V2500 Propulsion System — Nacelle

SERVICE BULLETIN

NACELLE — PNEUMATIC — SUPPORT BRACKETS, SENSE LINES,
ENVIRONMENTAL CONTROL SYSTEM - REPLACEMENT OF

V2500-NAC-36-0002

ECS Sense Line Support Bracket Installation
Figure 1

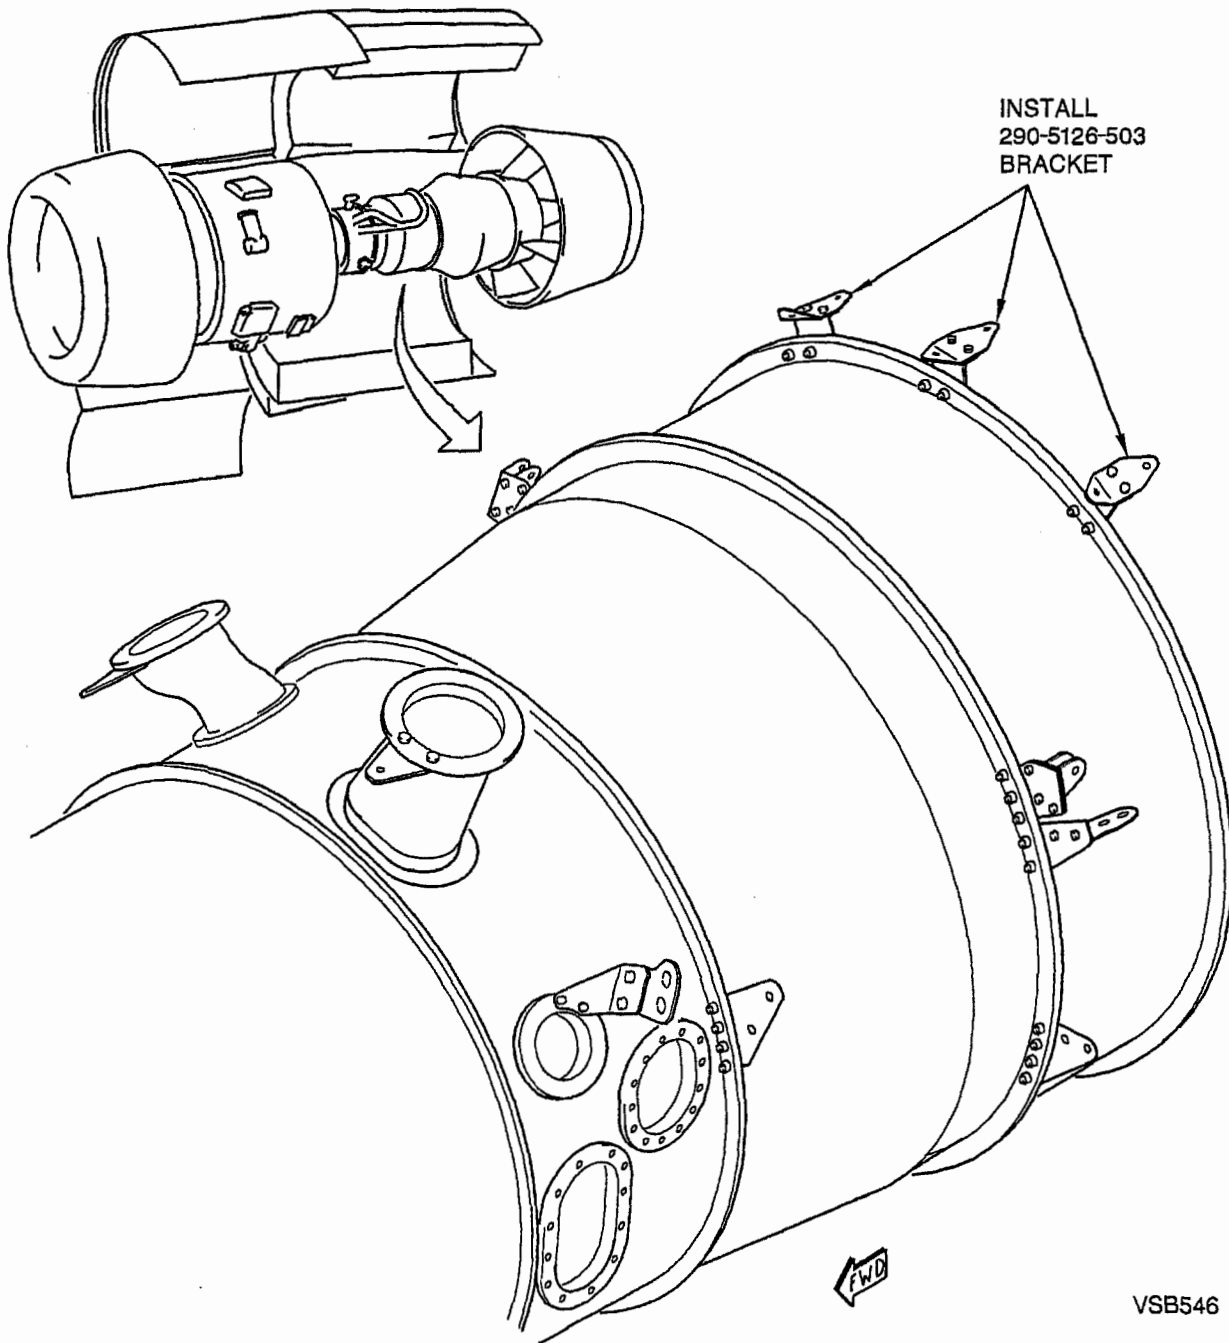
Environmental control system (ECS) sense lines can interfere with the ECS system crossover duct.

Replaces the ECS sense line engine support brackets.

- (1) Install the 290-5126-503 brackets on the engine brackets with the bolts, washers, and nuts. Torque the nuts to 20-25 lbfin (2-3 Nm). Refer to Figure 1.
